NOTE - CONSTRUCTION ISSUE C03

SITE/PROJECT: **A59 KEX GILL DIVERSION**

TITLE: **Landscape Ecology Mitigation Monitoring and Management Plan (Sheet 4 of 10)**

SCALE @ A1:	1:1000	CHECKED:	SF	APPROVED:	AW
PROJECT NO:	70049554	DESIGNED:	SF	DRAWN:	MM
DRAWING NO:	NYKGGD-WSP-ELS-SG-DR-LE-00030	DATE:	AUGUST 2023	REV:	C03

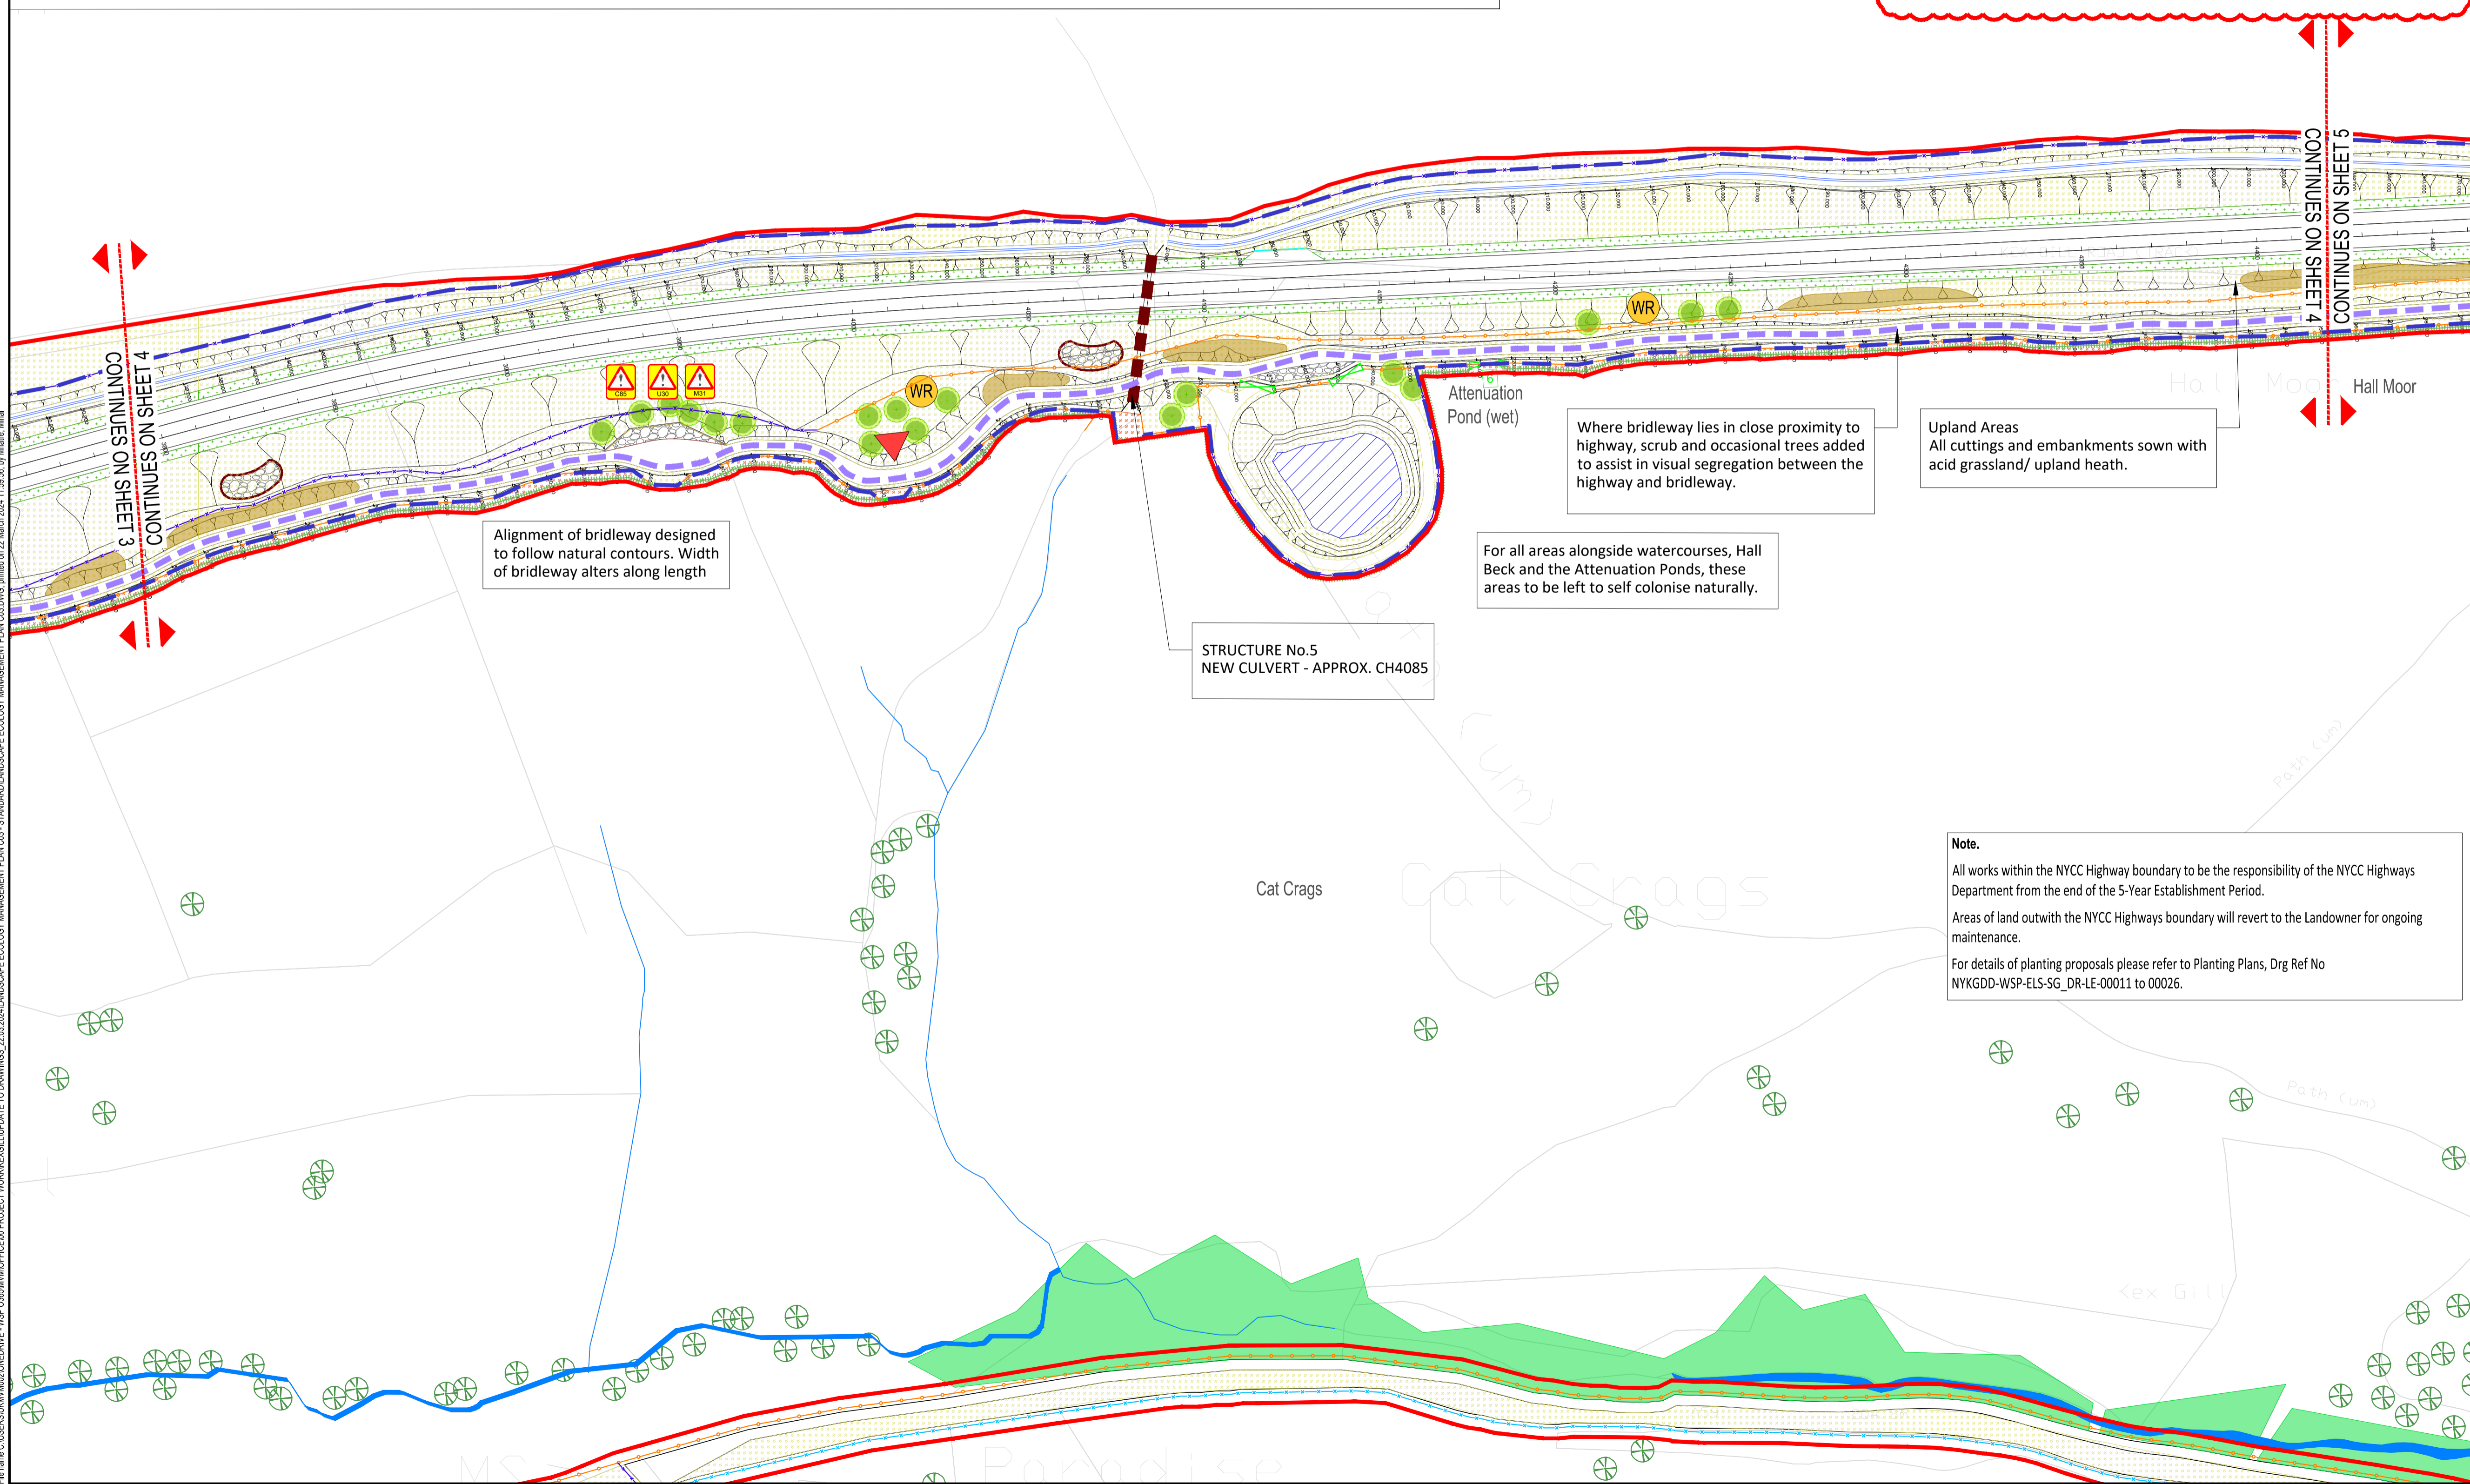
- Amendments to the design at Church Hill (minor amendements to the boundary treatments to allow for the road reconfiguration, and gates altered at church car park);

- Amendments to the design at Hall Lane (minor amendements to the boundary treatments to allow for the road reconfiguration);
- Diversion of Hall Beck (alteration to watercourse alignment and design);

- Soft landscaping around drainage areas including Attenuation Ponds (refer to Point 6);
- Siting of interceptor channels and filter drains (soft landscaping around changes in Point 3);

- Variation in slope angle on certain sections (change in type of planting in certain areas due to underlying geotechnical feature placement associated with soil stability);

- Inclusion of reinstatement works for areas used as temporary construction compounds;
- Areas of woodland and scrub planting are to be reconfigured, following recent tree clearances; and

- No. 8 additional tree guards will be provided within livestock fields near Blubberhouses Hall to protect growing trees.
